Access Compliance Report

Public Rights-of-Way

Intersection ID: 29920	Main Street: NORTHRIDGE_DR	Cross Street: WYNDHAM_HILL_DR	Location: NE
ADA ID: 1D57407CA406	Ramp Type: PerpDiag	Initial Pass/Fail: Fail	Overall Compliance: No
			Severity Score: 21.25

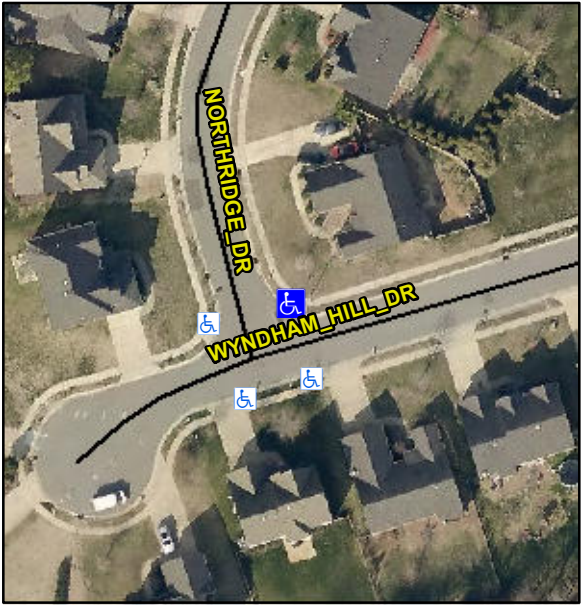
Codes/Mitigation Info/Possible Solution		Field Measurements/Component Compliance			
	Possible Solutions:				
	Remove & Replace Curb Ramp With Two New Directional Ramps or Equivalent.				
	Surveyor Notes:				
	N/A				
	PROW/ADA:				
	R304.5.1, R304.2.2				
	Street 1 Name	NORTHRIDGE DR		Stop Condition-Street 2	StopSign
	Street 2 Name	WYNDHAM HILL DR		Stop Condition-Street 1	None
	Total Cost:	\$	3200.00		
		Compliance	Description	Data	Compliance
		N/A	Ramp Length (in)	52.0	No
		No	Ramp Width (in)	38.0	Yes
		N/A	Flare Type LT	N/A	N/A
		N/A	Flare Slope LT (%)	N/A	N/A
		N/A	Flare Traversable LT?	N/A	N/A
		N/A	Landing Length (in)	N/A	N/A
		N/A	Landing Width (in)	N/A	N/A
		N/A	Landing Slope (%)	N/A	N/A
		N/A	Landing X Slope (%)	N/A	N/A
		N/A	Landing Curb? (Y/N)	N/A	N/A
		N/A	Shared Landing?	N/A	
		N/A	Gutter Ponding?	N/A	N/A
		N/A	Gutter Lip Ht (in)	N/A	N/A
		N/A	Painted X Walk1?	No	N/A
			X Walk 1 Direction	To W	
		N/A	X Walk 1 Width (in)	N/A	N/A
